CITY OF SURPRISE
Planning and Zoning Commission Agenda
16000 N. Civic Center Plaza
Surprise, AZ 85374

Case: FS15-249

Project Name: Iris USA

A. The Site Plan prepared by Ware Malcomb dated 7/31/15 will be revised and submitted for review to include the following modifications:

SHEET
A1.0

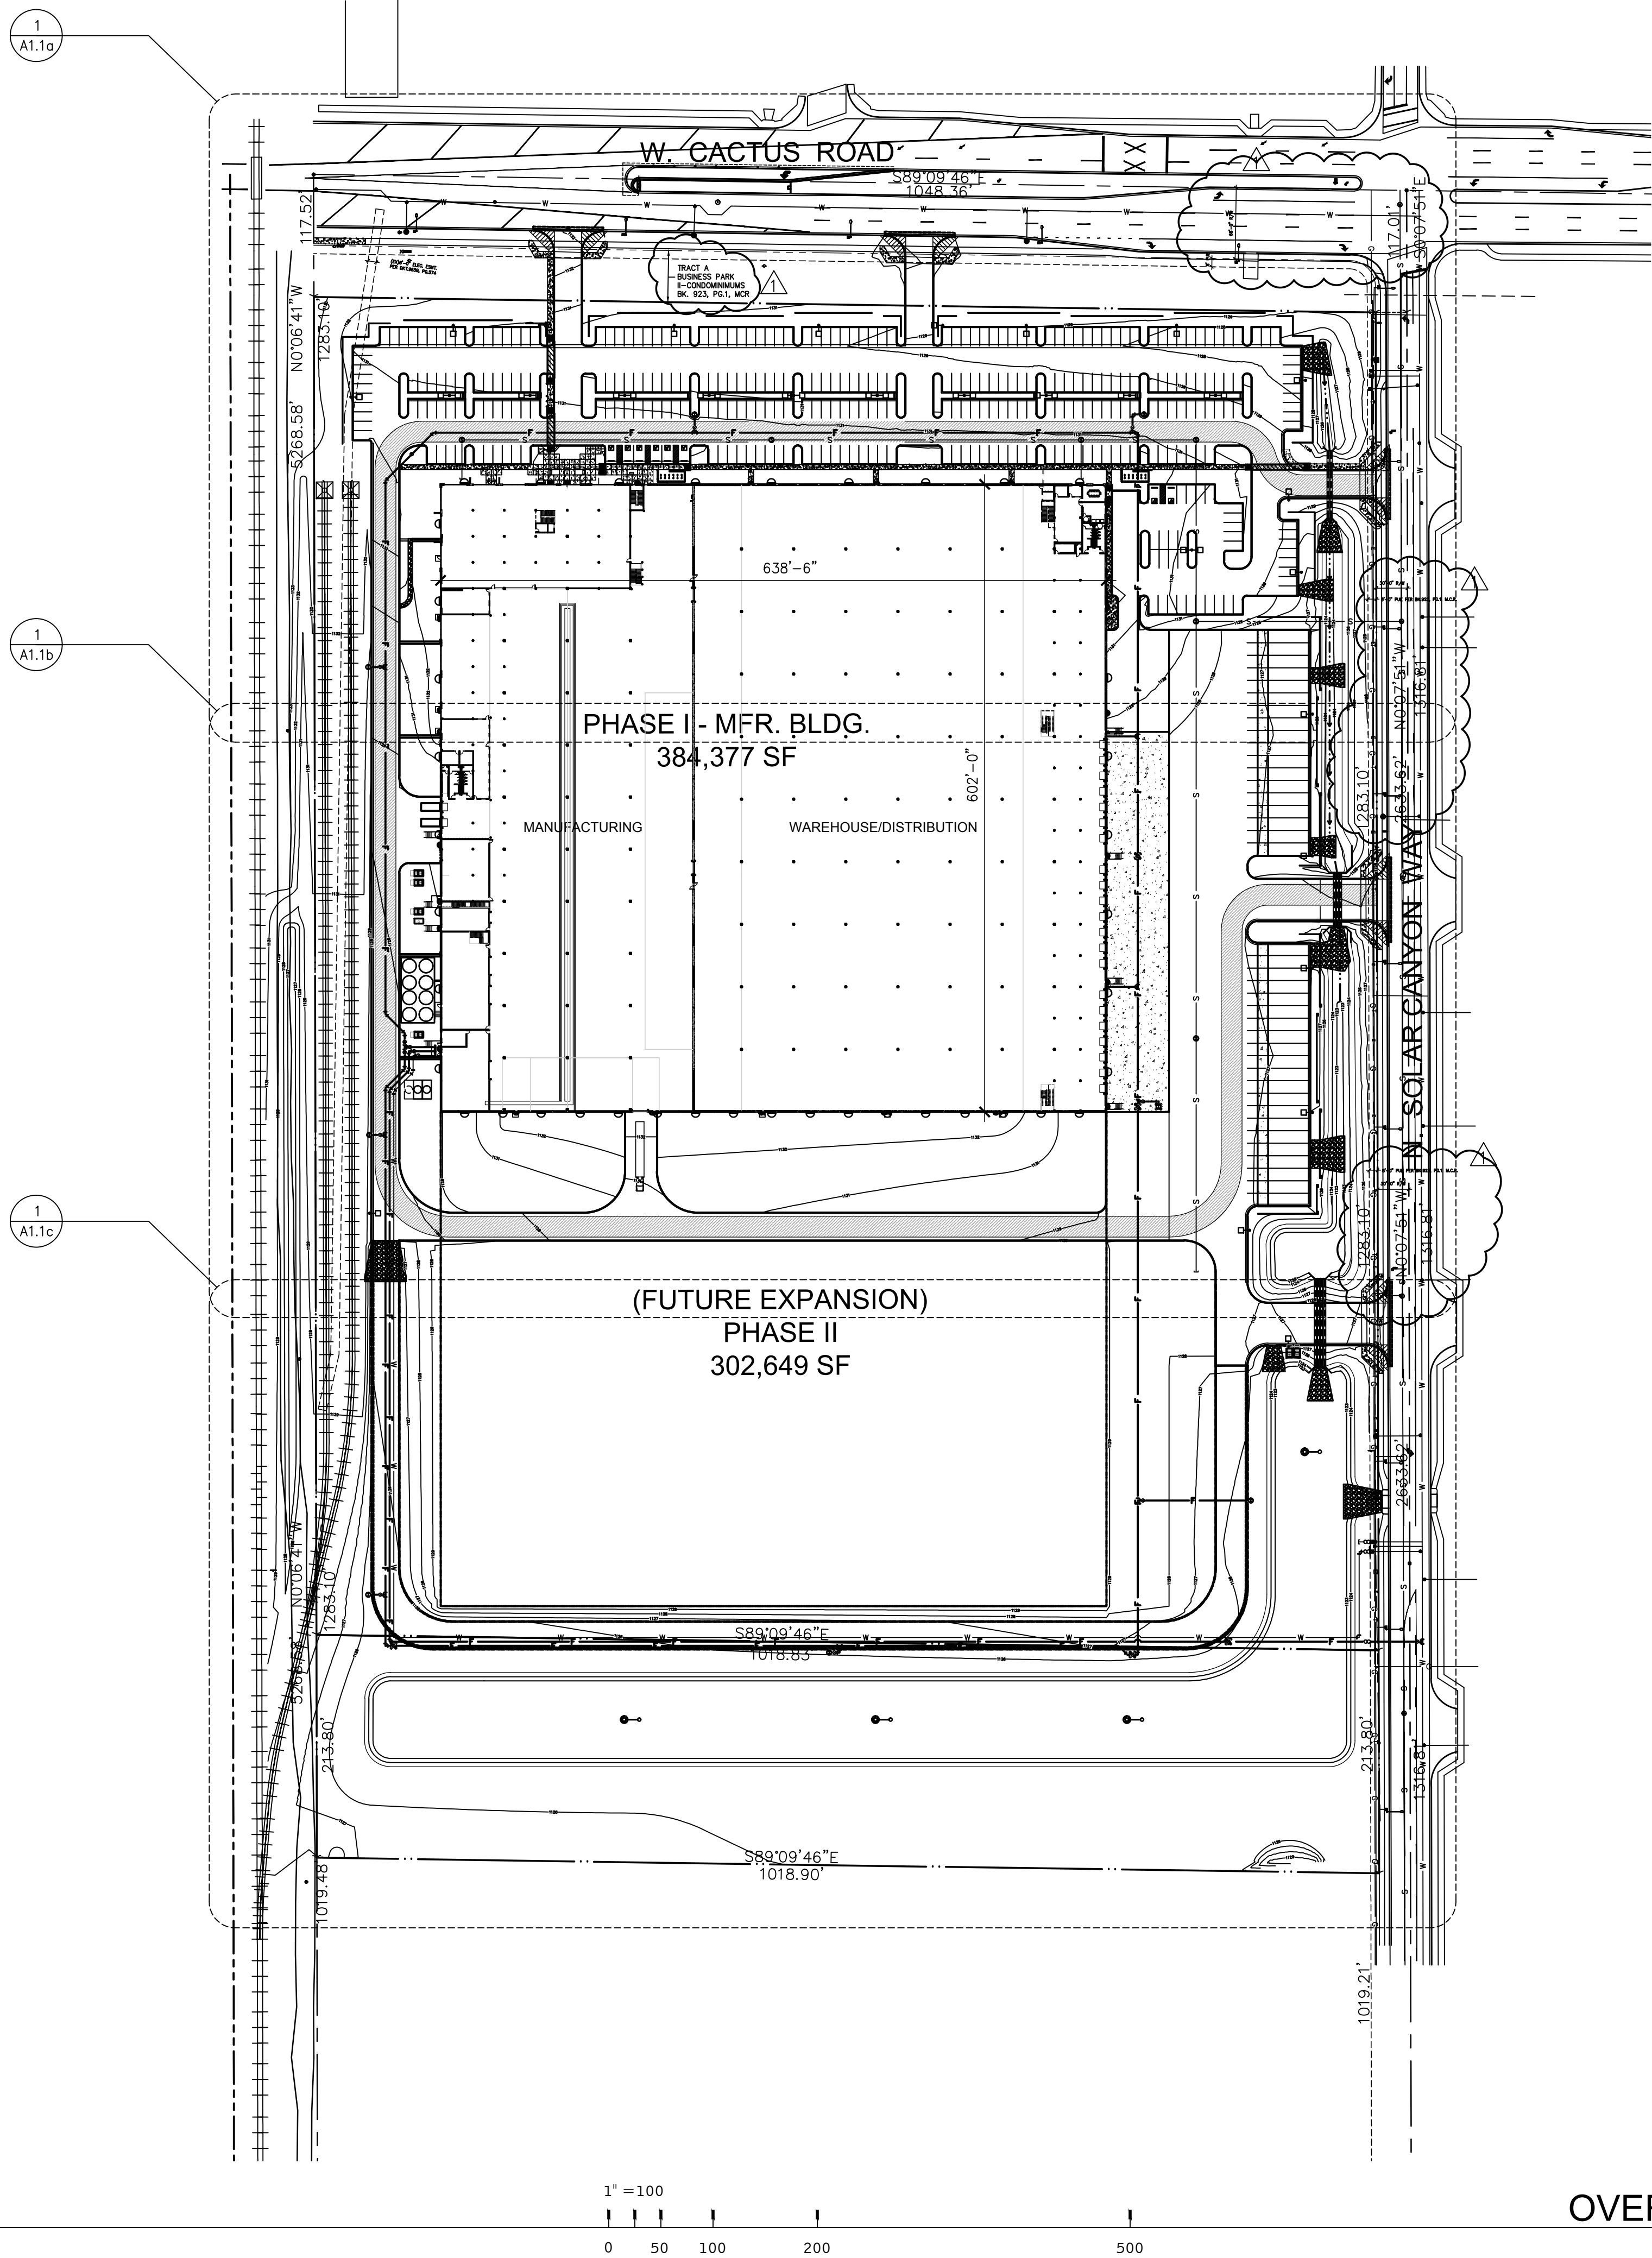
2. Provide sight visibility lines at each drive per Detail 4-01. Sight lines appear to be calculated from Detail 4-02, not 4-01.
3. Provide sight lines (calculated from Detail 4-01) at Cactus Road and Solar Canyon Way.
4. Include 100 year high water elevation
5. Label storage length for the turn lane (length to match required length in the TIA)

A1.1a

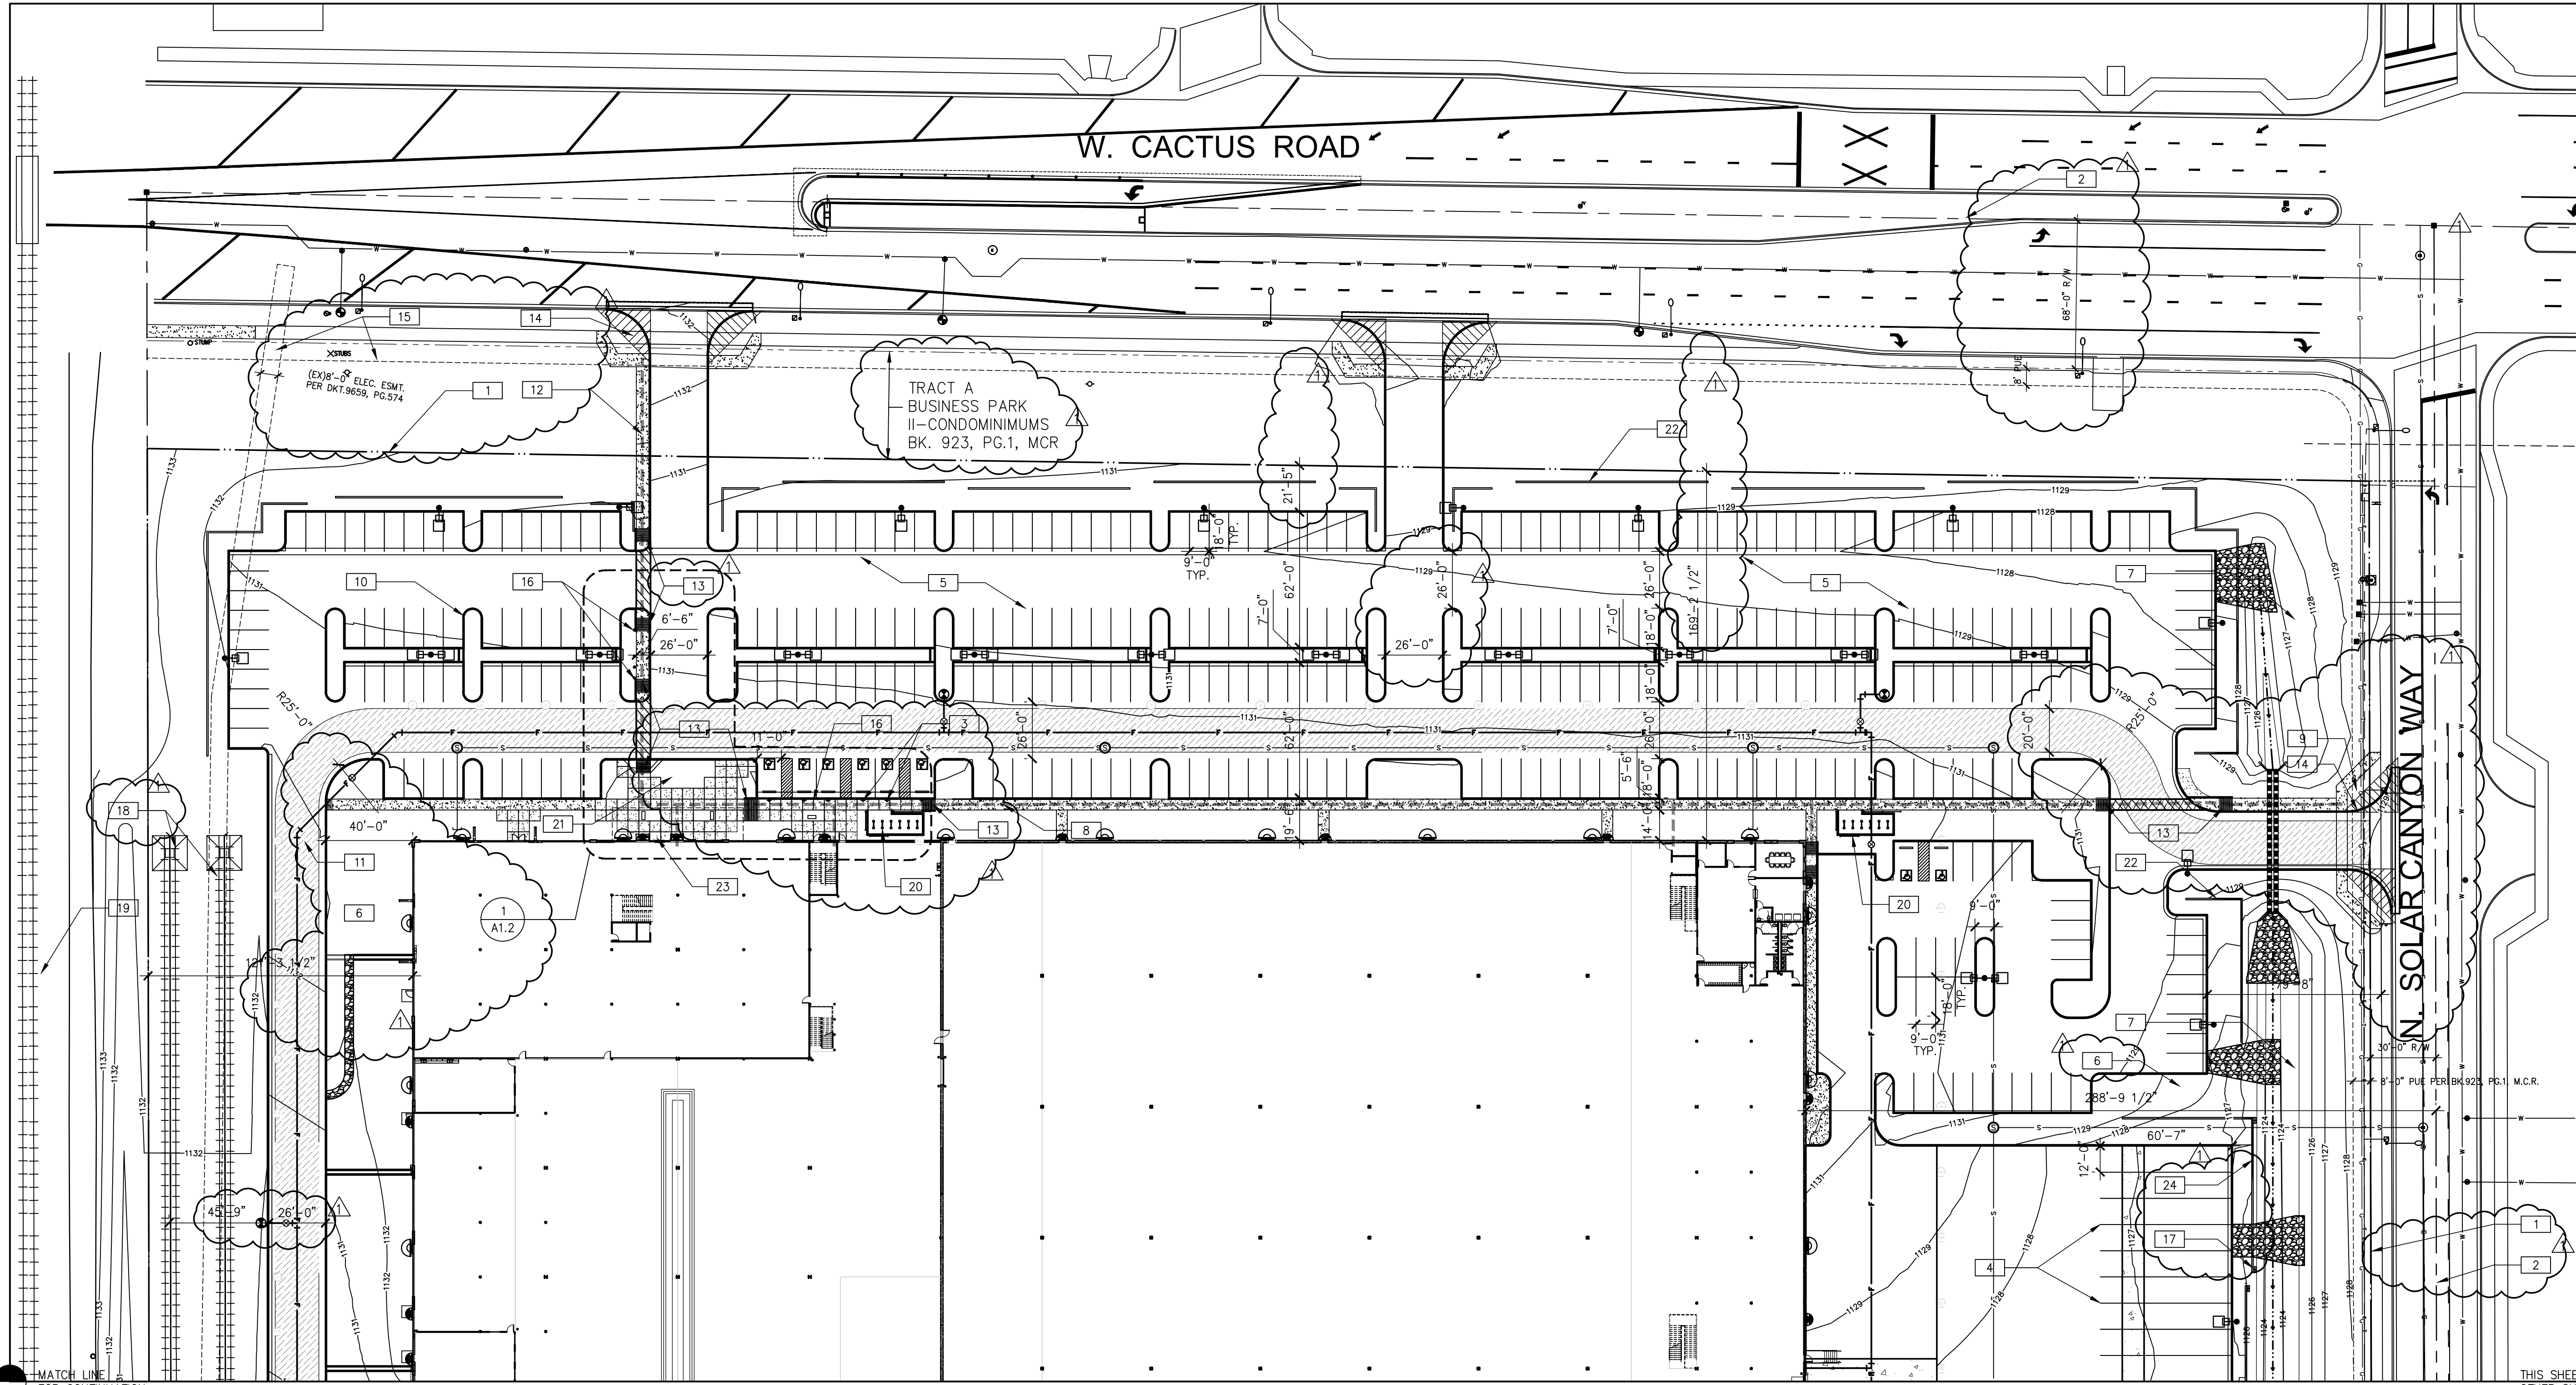
6. Show proposed striping on Cactus Road (and shade back what is to be obliterated)
7. Show proposed median on Cactus Road (and shade back what is to be removed)

SHEET
A1.1b

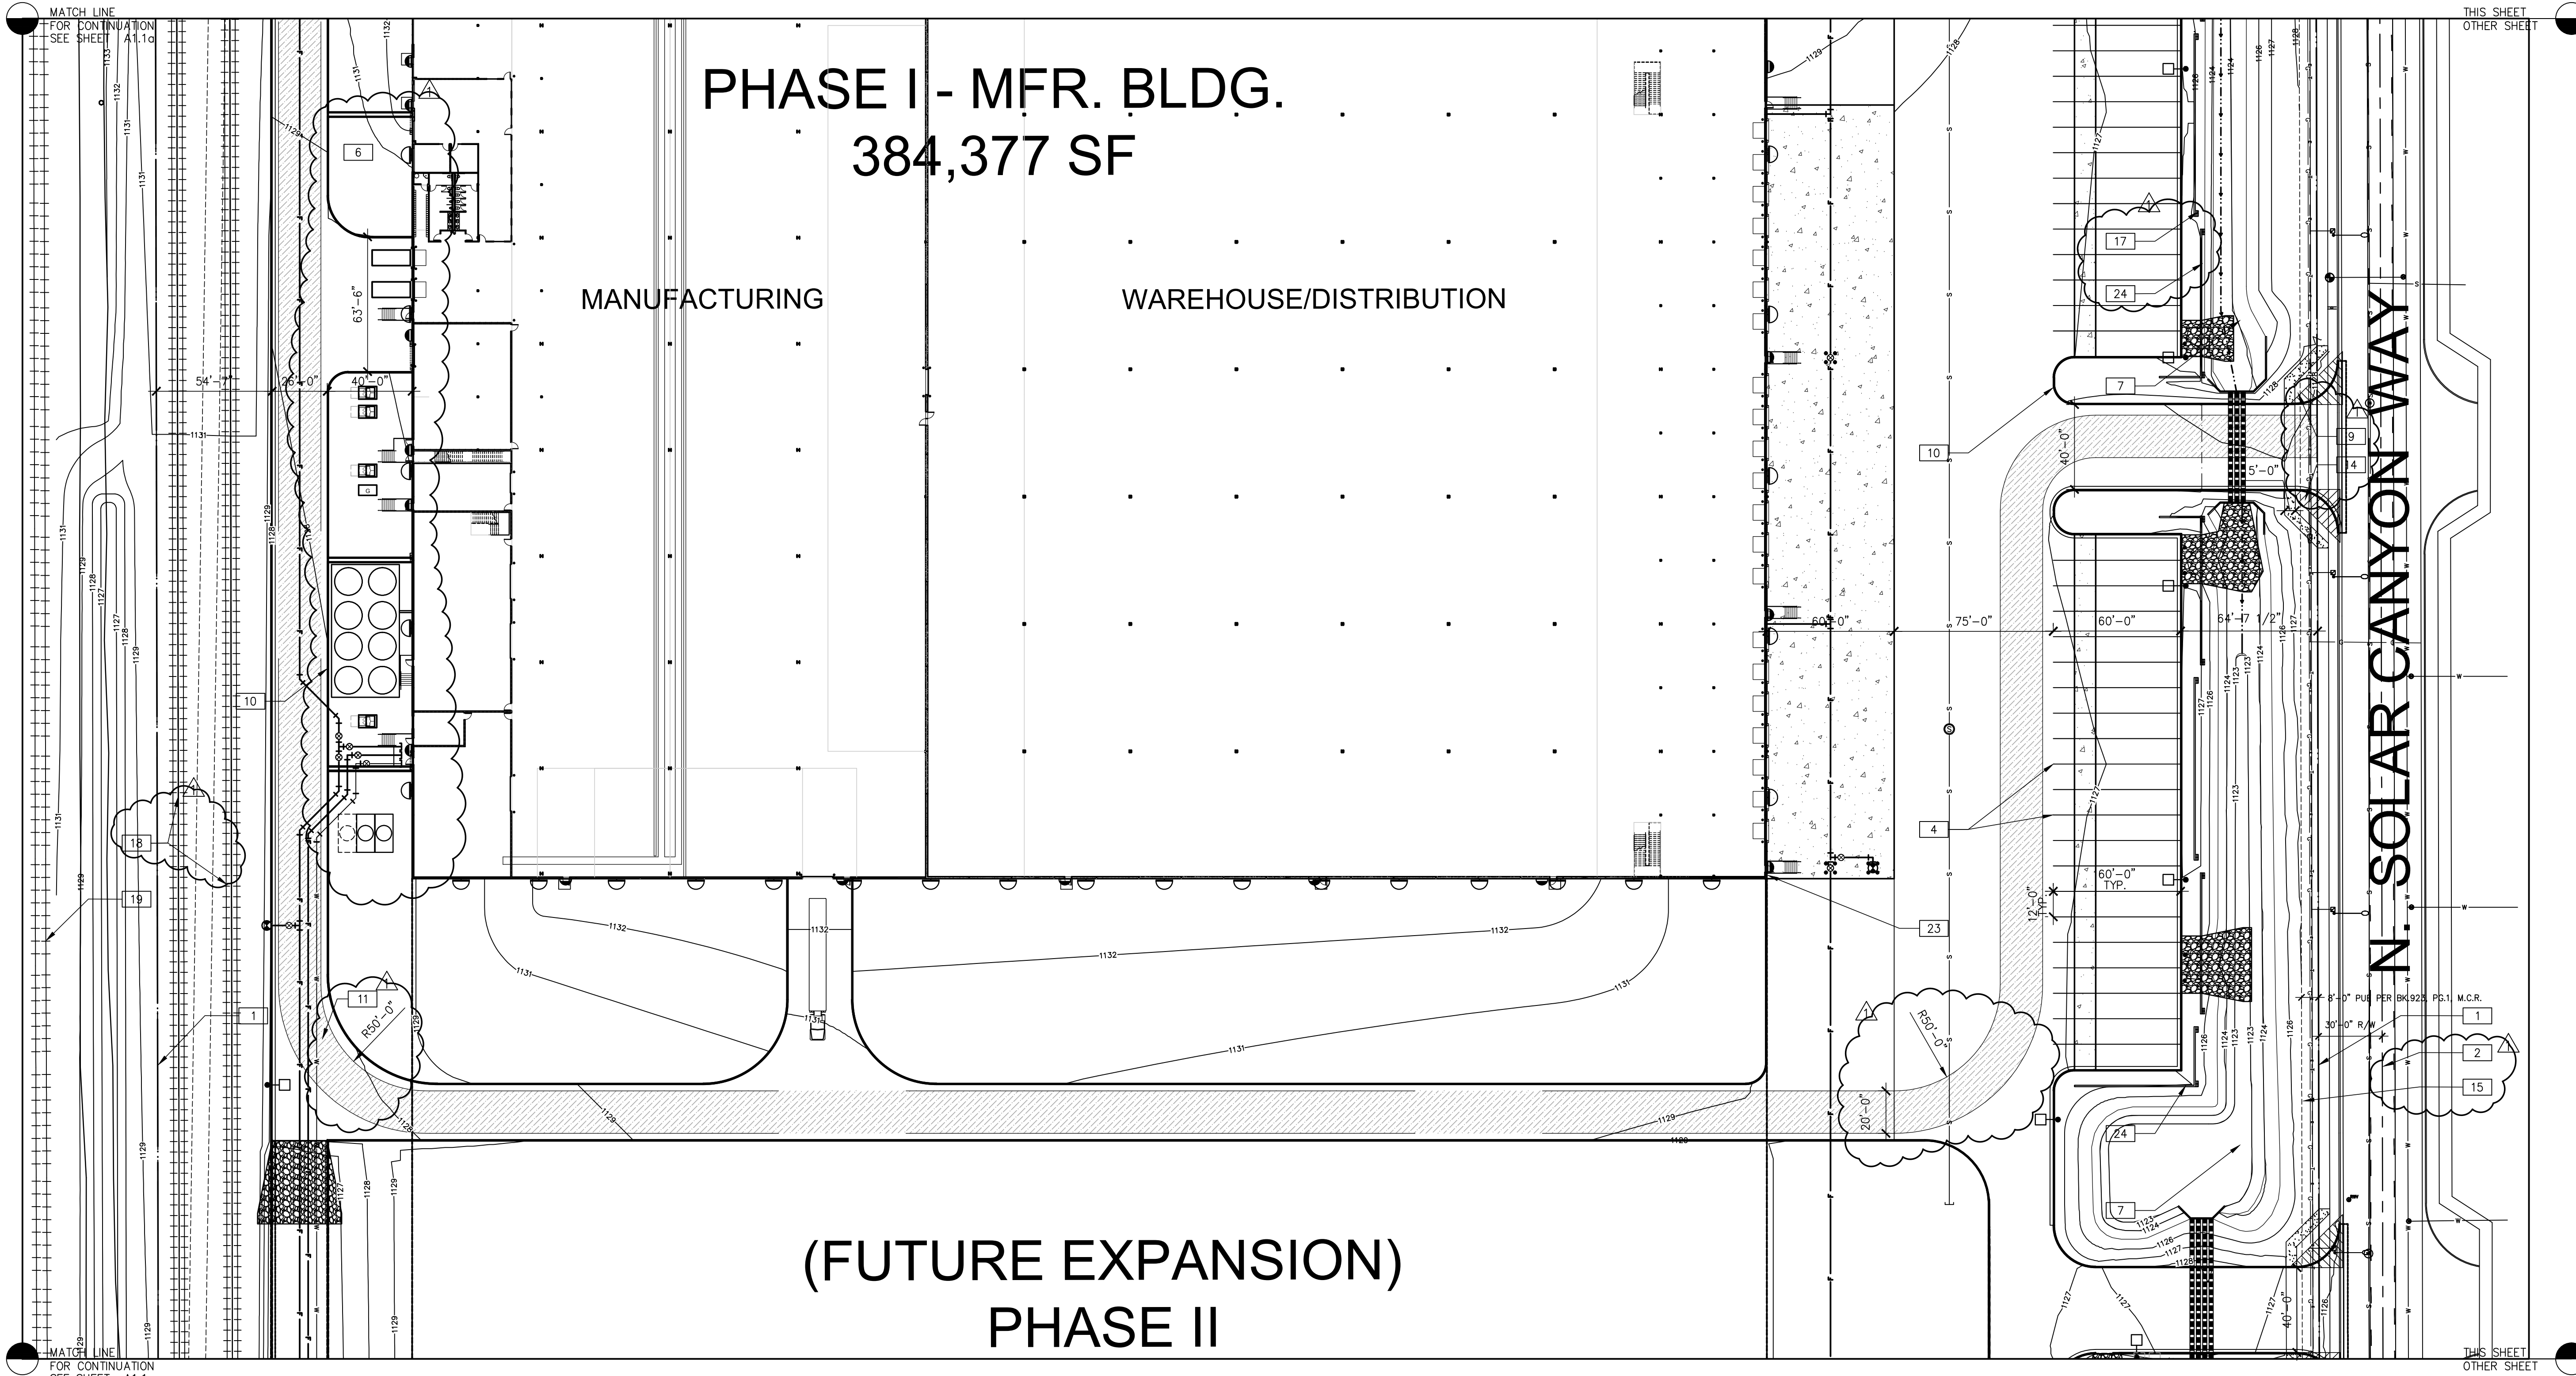
8. Provide applicable notes only
